**THE IMPROVEMENTS OF
PROCTOR ROAD
FROM REDWOOD ROAD TO CAMONO ALTA MIRA
CASTRO VALLEY, ALAMRDA COUNTY, CALIFORNIA
SPECIFICATION NO. 2491**

This addendum is issued by the County of Alameda, Public Works Agency, Construction and Development Services Department, 399 Elmhurst Street, Hayward, CA 94544.

Receipt of this Addendum No. 1 must be acknowledged on the form in the bid proposal in writing.

DATE: MAR 2025
WORK ORDER NO: R32144
SPECIFICATION NO: 2491
SHEET NO: 20 OF 59
FILE NO: U-639

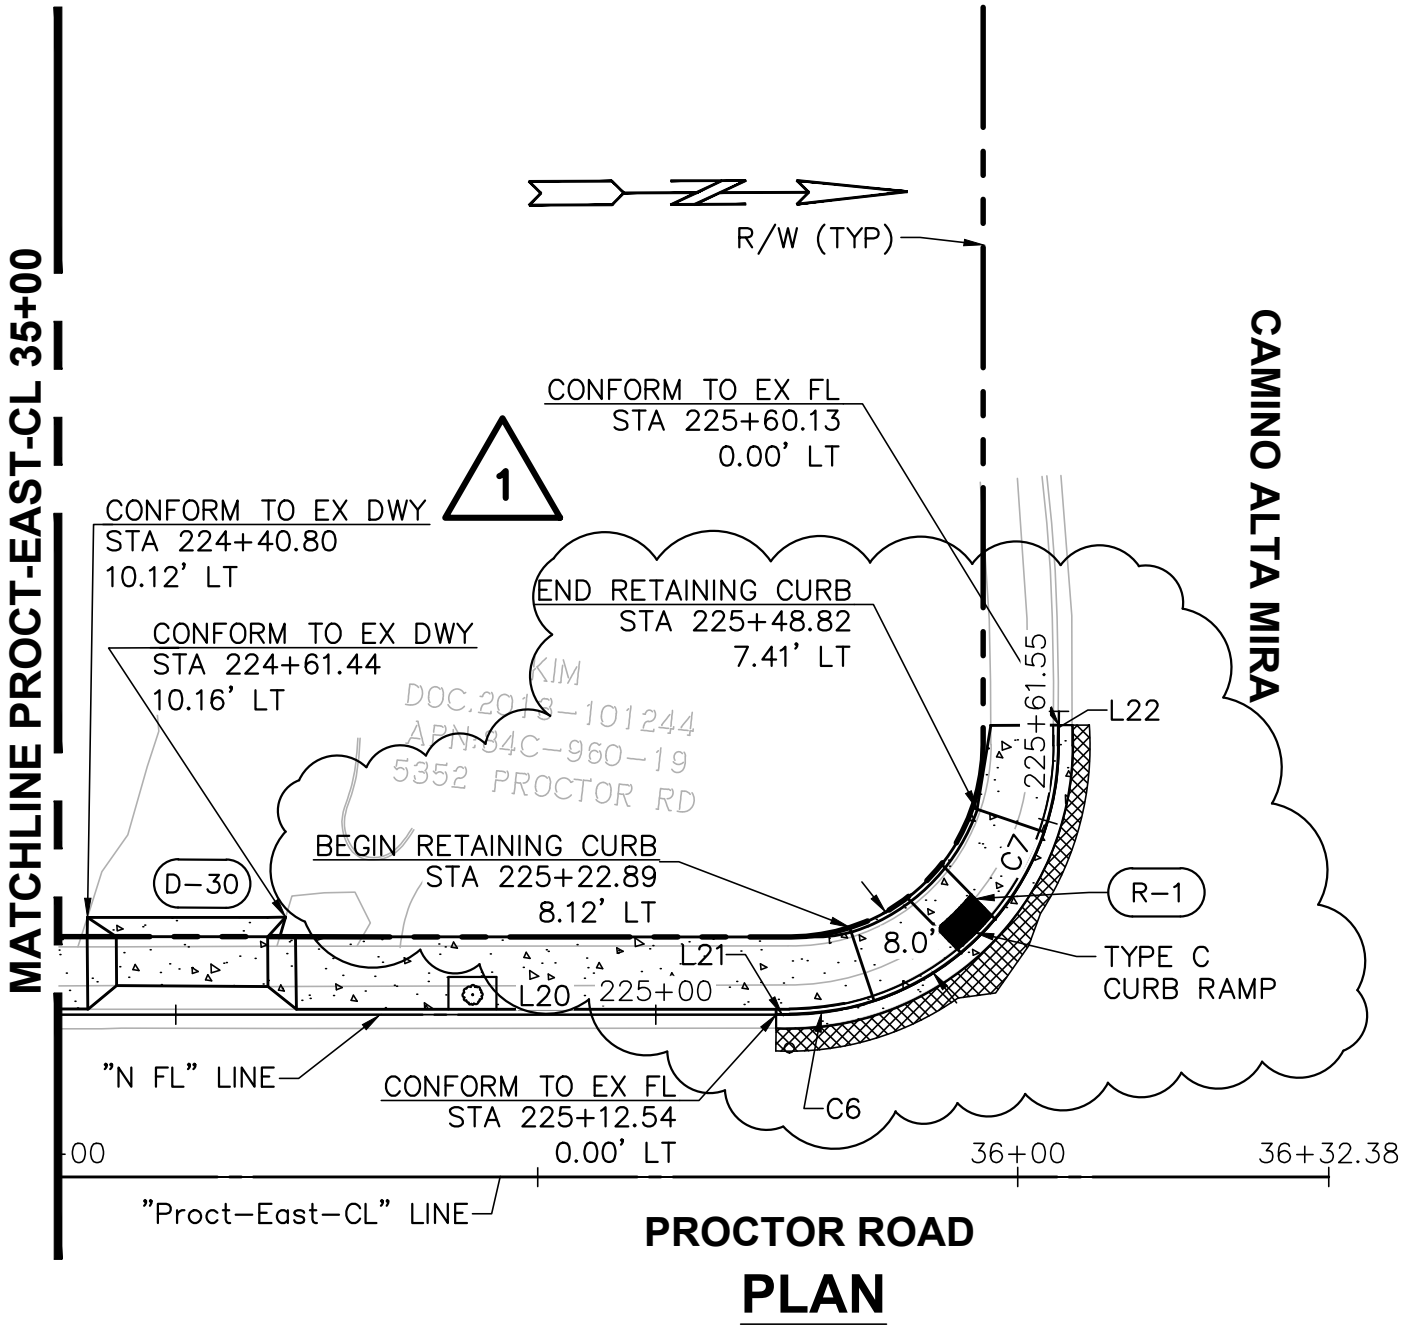
NO.	DESCRIPTION	BY	DATE
1	REVISED CURB RAMP DETAILS	JK	4/8/25
2			
3			
4			
5

DATE	SCALE
MAR 2025	1"=20'
WORK ORDER NO.	R32144
SPECIFICATION NO.	2491
SHEET NO.	25 OF 59
FILE NO.	U-639

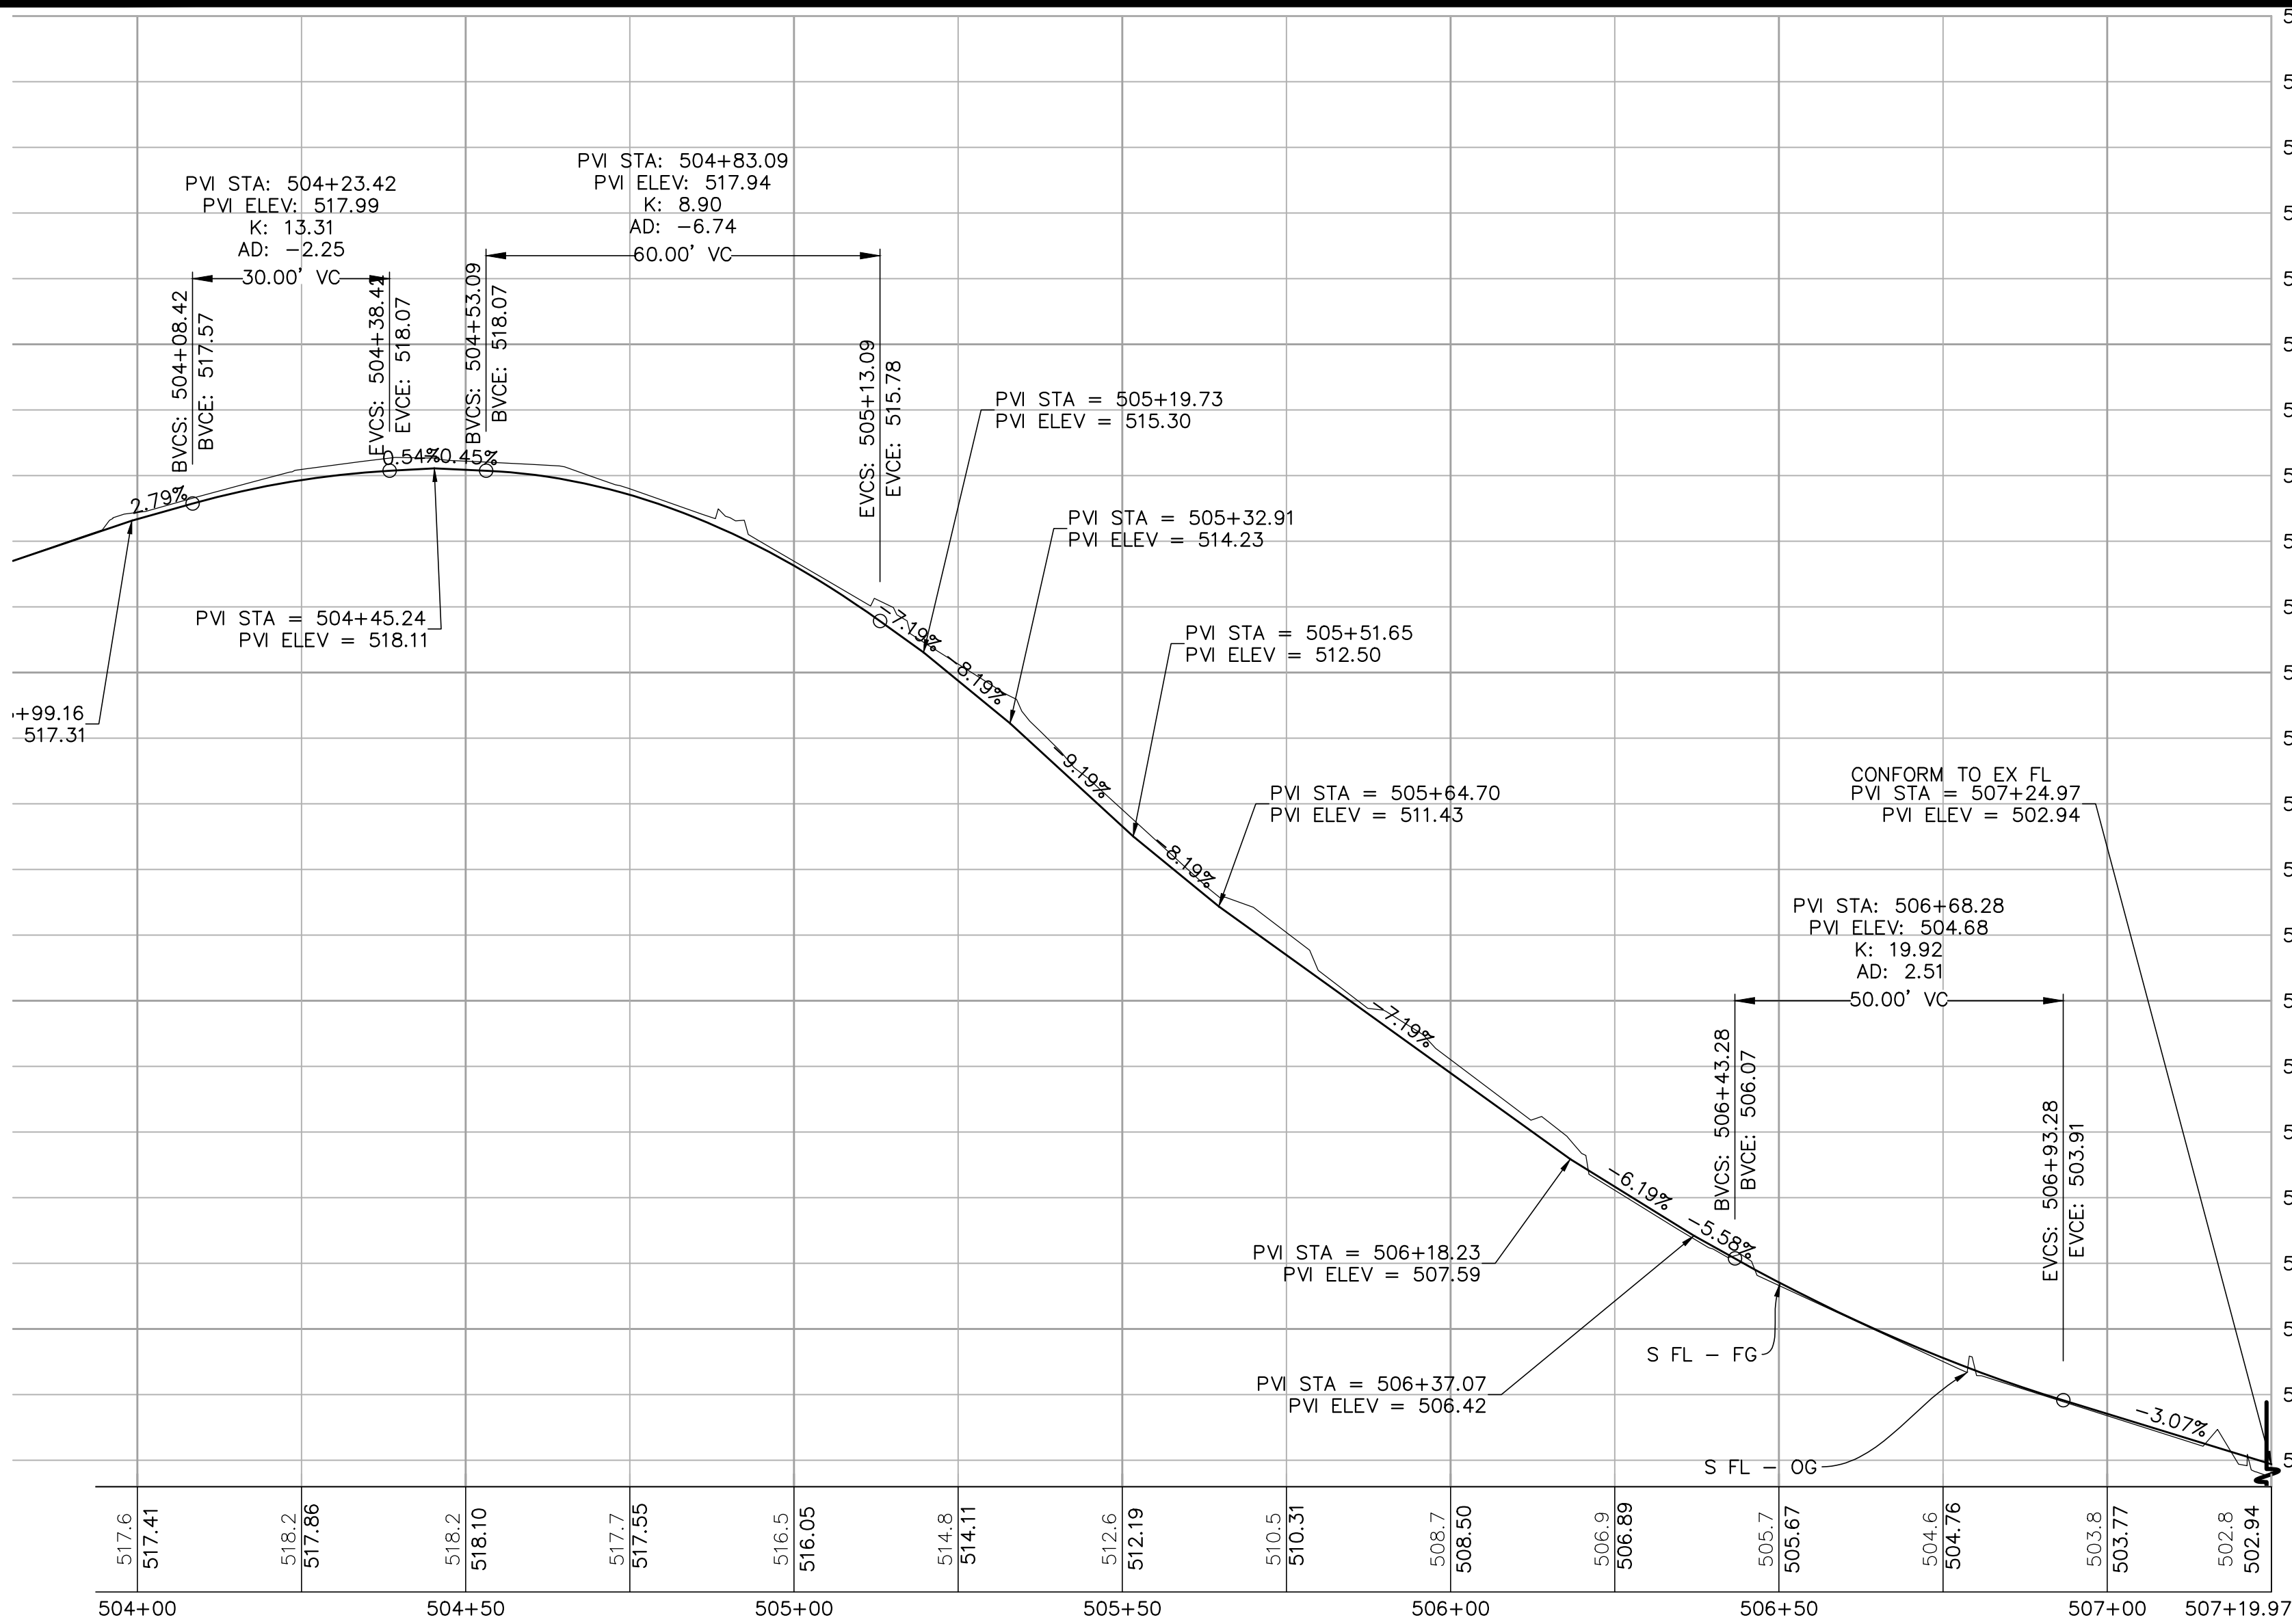
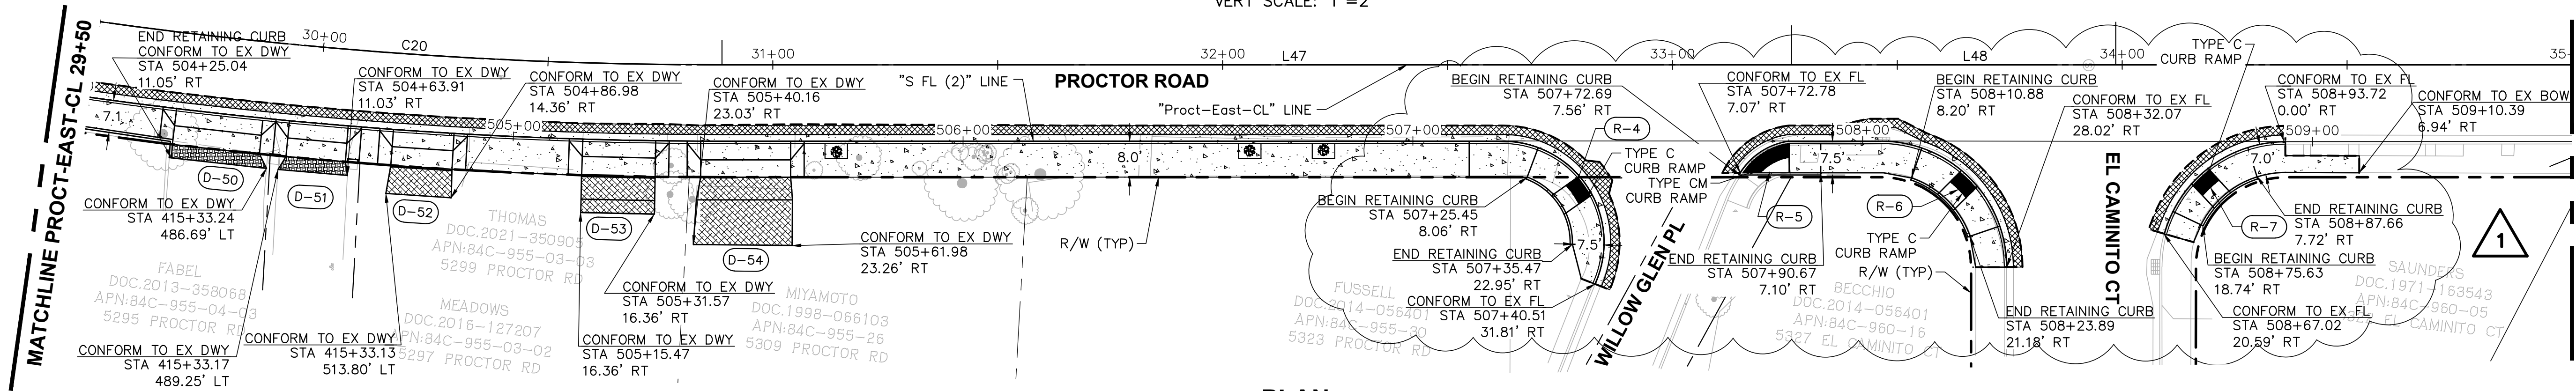
REVISIONS				APPROVALS			
NO.	DESCRIPTION	BY	DATE	APPROVED	DESIGNED	CHECKED	DATE
1	REVISED CURB RAMP DETAILS	JK	4/8/25	JC			
2							
3							
4							
5							
6							
7							
8							
9							
10							
11							
12							
13							
14							
15							
16							
17							
18							
19							
20							
21							
22							
23							
24							
25							
26							
27							
28							
29							
30							
31							
32							
33							
34							
35							
36							
37							
38							
39							
40							
41							
42							
43							
44							
45							
46							
47							
48							
49							
50							
51							
52							
53							
54							
55							
56							
57							
58							
59							
60							
61							
62							
63							
64							
65							
66							
67							
68							
69							
70							
71							
72							
73							
74							
75							
76							
77							
78							
79							
80							
81							
82							
83							
84							
85							
86							
87							
88							
89
